[FDP Forum](#) / [Fender Guitar Mods and Repairs](#) / [Tele 4-way switching](#)

Diagram P/11 099-2250-199

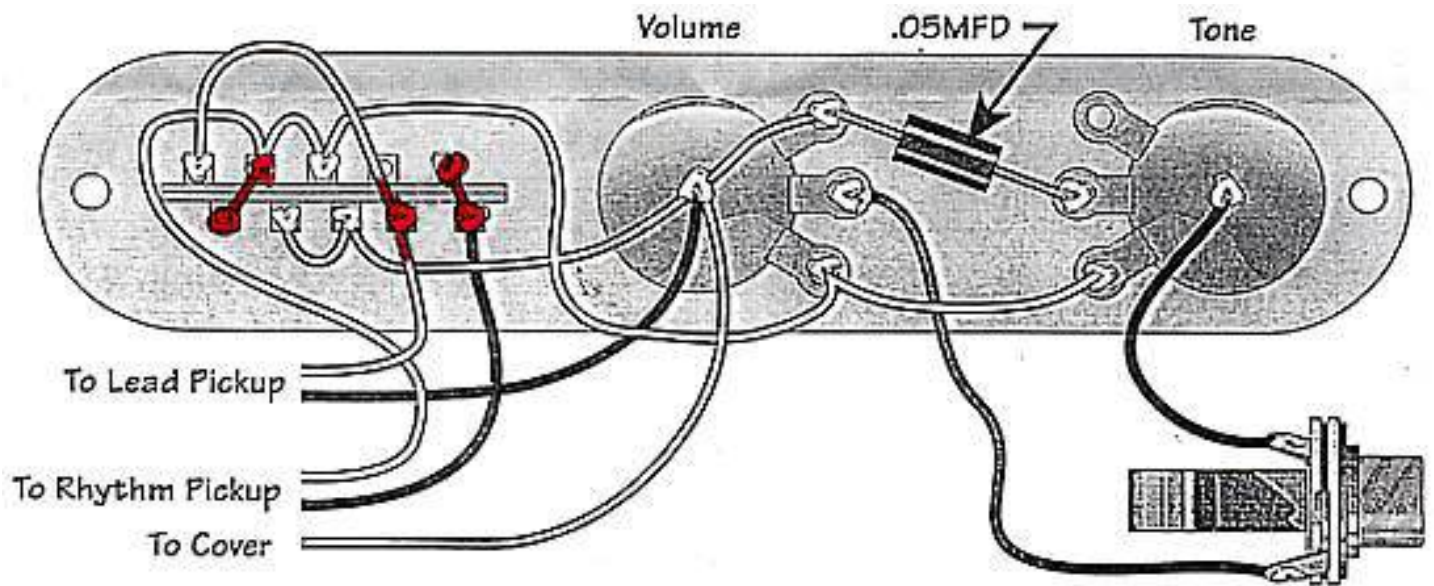
<p>unquiet Darkest Scotland <i>F-type Jaguar driver.</i></p>	<p>Oct 7th, 2001 03:30 PM Edit Profile</p> <hr/> <p>The mods are drawn in red. The one at the left of the diagram suppresses the noise in the 'bridge' position, the ones at the right improve reliability and reduce switch noise. You can do either or both, they are independent.</p> <p>Also, I have now done the mod so the series position is at the bridge end of the switch... this makes more sense to me as I usually think of 'hard right' as the lead sound, which the series sound is best for. It's actually easier to isolate the ground from the bridge pickup too, a lot of the newer Teles have a separate connection for the bridge ground already, as they now don't have the pickup baseplate. I haven't done a diagram for this though.</p> <p><u>4-Way Switch diagram</u></p> <p>(This message was last edited by unquiet at 03:32 PM, Oct 7th, 2001)</p>

Modifications to Fender's 4-Way Tele switching (in red). The link at left (upper tag #1 to lower tag #1) stops noise in the 'bridge-only' position, the links at right (remove upper tag#4 to lower tag #4 link, add upper tag #4 to lower rotor and lower tag #4 to upper rotor) make the series connection more reliable.
